Sydenham to Bankstown Metro: Key issues and opportunities

December 2017

Endorsed by Council 28 November 2017

The City of Canterbury Bankstown (Council) provides comment on the Metro Southwest EIS to highlight the significant city shaping opportunities that would be missed if the current plan was constructed as proposed.

Figure 3: TfNSW EIS Concept Plan for Wiley Park Station; annotated by Canterbury-Bankstown Council

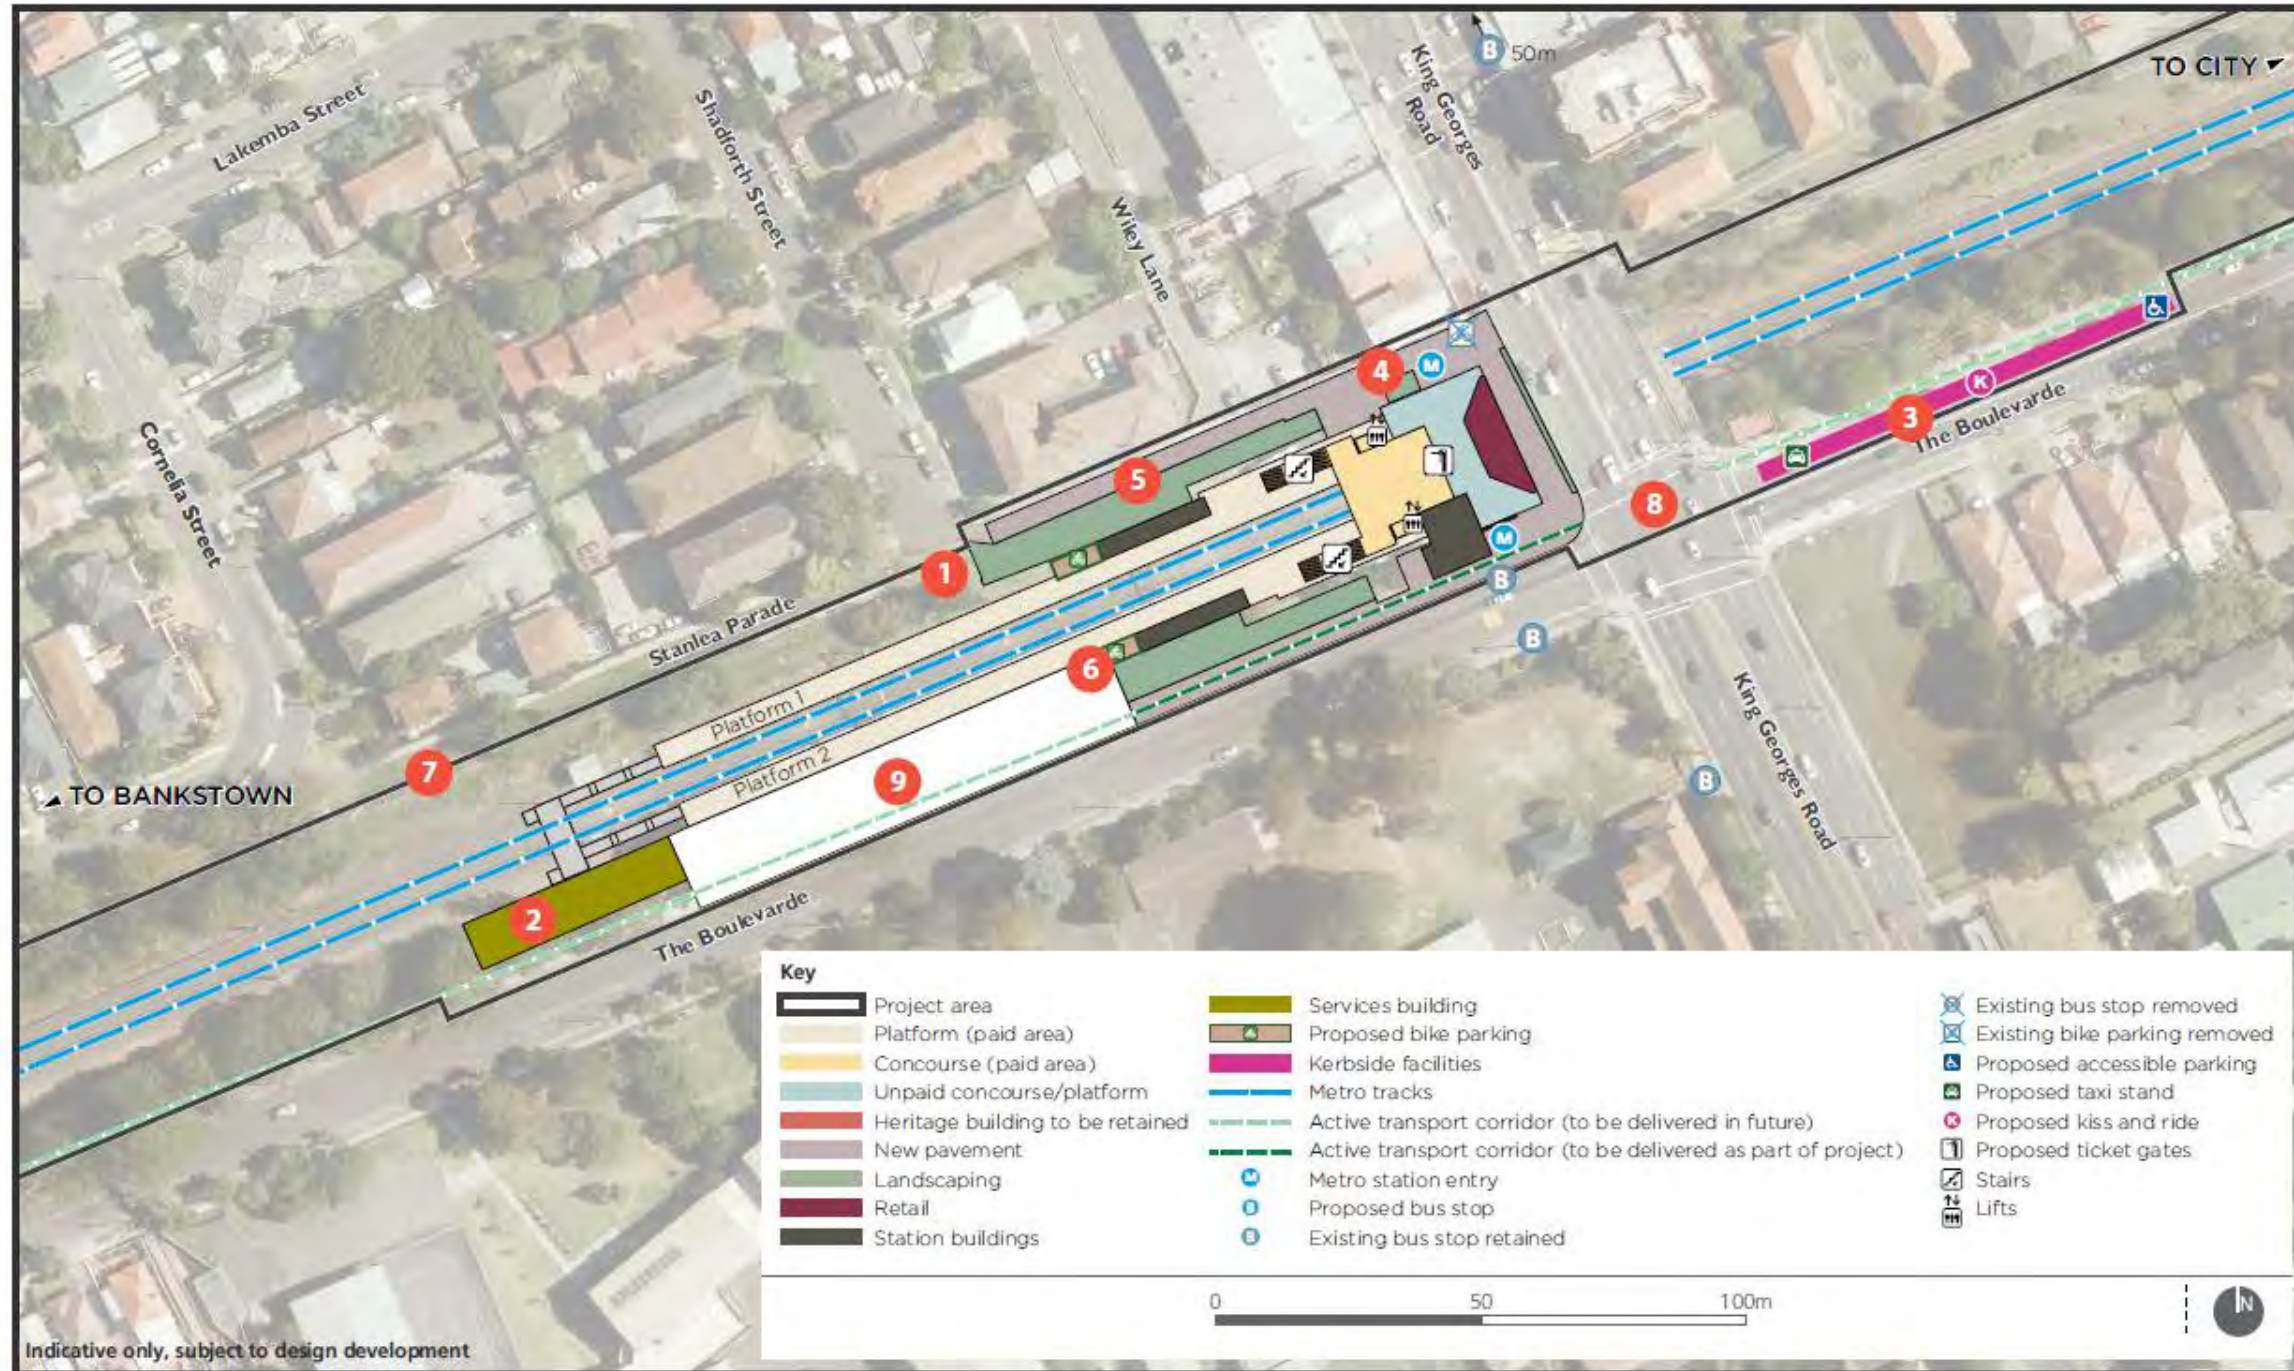
6	<p>Additional bike parking required - retain existing facility, proposed is distant from entry</p>	<p>The EIS should ensure that cycling facilities are given greater priority to align with the station hierarchy of transport modes.</p> <p>Relocate bike parking to station entry both sides</p>	<ul style="list-style-type: none">• Convenient, safe and easy to use bike storage facilities located close to station entries.• Relocate bike parking to station entry both sides.• Ensure adequate bike parking.		EIS Figure 8.16	14(1)-14(4)
7	<p>Potential for new commuter parking on railway land between Shadforth Street and Cornelia Street aligning with Stanlea Parade</p>	<p>Consider providing additional park-and-ride spaces at Wiley Park, if possible, to offset losses at other stations, such as Campsie, Belmore and Bankstown.</p> <p>Increase connections to and from the station for pedestrians and cyclists and across corridor; enhance kiss n ride.</p>	<ul style="list-style-type: none">• Provide additional park-and-ride spaces at Wiley Park and upgrade spaces to meet DDA compliance.• Concept plan amendment: Stanlea Parade becomes one way road with kiss-and-ride at the eastern end. TfNSW to dedicate land for this.	<ul style="list-style-type: none">• Not preclude providing additional park-and-ride spaces at Wiley Park, potentially through transfer of land from Sydney Metro to Council for future works or re-locating development sites so that those closer to the station are used for development and parking is located further away as part of meeting the modal hierarchy.	EIS Section 11.4.11 Page 11-33	13 (2)

9	Consider increasing capacity of park and ride in conjunction with Council works project funded by RMS	Consider providing additional park-and-ride spaces at Wiley Park, if possible, to offset losses at other stations, such as Bankstown.	<ul style="list-style-type: none">• Provide additional park-and-ride spaces at Wiley Park and upgrade spaces to meet DDA compliance.	<ul style="list-style-type: none">• Not preclude providing additional park and ride spaces at Wiley Park, potentially through transfer of land from Sydney Metro to Council for future works or re-locating development sites so that those closer to the station are used for development and parking is located further away as part of meeting the modal hierarchy.	EIS Section 11.4.11 Page 11-33	13 (2)
---	---	---	--	--	-----------------------------------	--------

Figure 4TfNSW EIS Concept Plan for Lakemba Station; annotated by Canterbury-Bankstown Council:

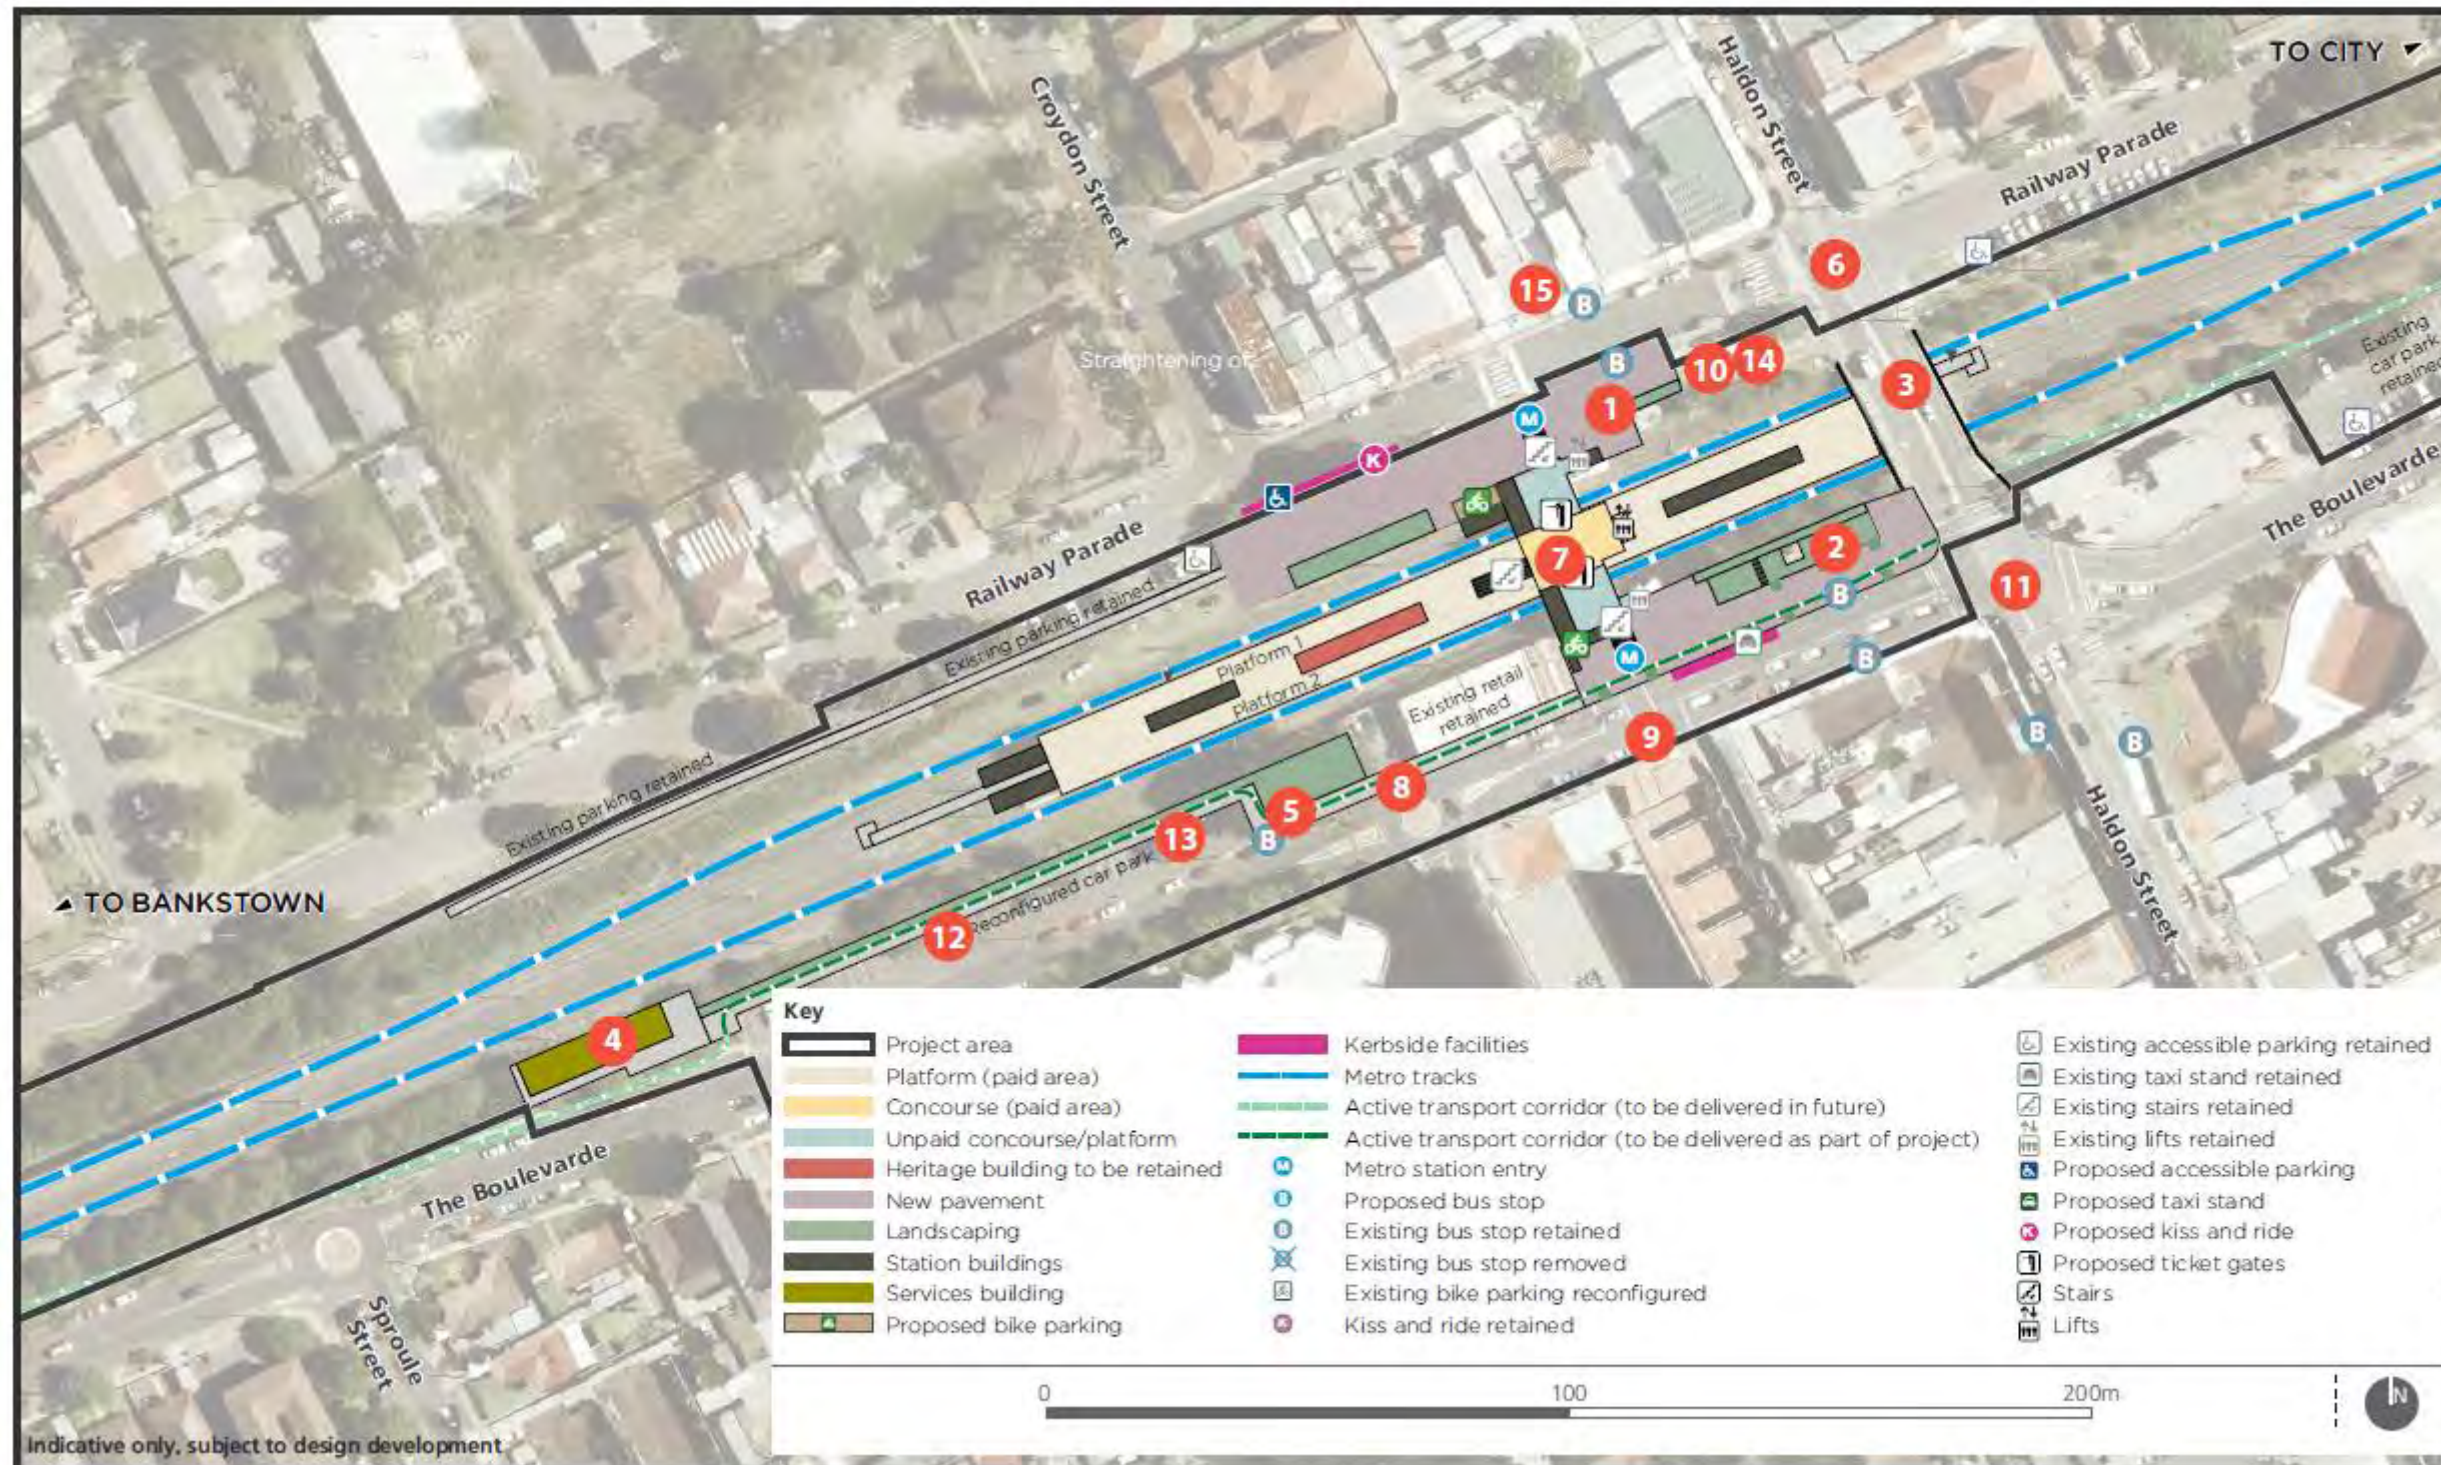
2	<p>Reduction of park size and relocation of War Memorial</p> <p><i>Submissions Report Part 2 – Creating Better Places: Opportunities for our Metro Centres that outlines alternative visions for Lakemba</i></p>	<p>It will be difficult to assess the exact implications for the War Memorial and evaluate the impacts on the park once the project has been approved.</p> <p>In Part 1A of the EIS, it is suggested the war memorial is retained. In Part 1B the mapping suggests the War Memorial is to be removed (Figure 14.5). Council is assuming that the park within which the War Memorial sits is to be reduced in size and therefore, the War Memorial relocated.</p> <p>If this is the case, Council seeks clarity in the EIS to understand the exact impacts on the future park size, and if not, why the War Memorial needs to be relocated.</p> <p>This space is highly valued by the community and contributes to its character.</p> <p>Targeted engagement with the existing users of the war memorial/park.</p>	<p>Provide a well-integrated public realm in Lakemba able to service the important cultural functions of the centre.</p> <p>Refer to Submissions Report Part 2 – Creating Better Places: Opportunities for our Metro Centres</p>	<p>A master plan for the future delivery of a well-designed, safe and active station precinct that positively defines public space, connects seamlessly with the existing local centre, providing continuous weather protection and delivering customers to the upgraded existing station entry.</p> <p>Additionally, at Lakemba, important ceremonial public spaces need to be maintained or augmented in close and careful consultation with Council, existing users and community groups.</p>	Part 1A –Table 8.8 Part 1B – Figure 14.5	14 (1)-14 (4)

7	Need unpaid concourse connection	Introduce a detailed design solution for unpaid concourse connection at Lakemba station. Review design to allow free access across overbridge	Unpaid concourse connection. Provide free access to overbridge	Unpaid concourse connection. Provide free access to overbridge	EIS: Figure 8.14	14.1-14.4

additional paving, seating, shelter, lighting & artwork.				
15	Station design and surrounds reflective of the religious and cultural influences of the community	Cultural specific consultations will need to be included in the design phase of the project. TfNSW and to work directly with Council to ensure community needs are considered.	Final design is reflective of community expectations		EIS: Table 8.8, Figure 8.14	14.1-14.4
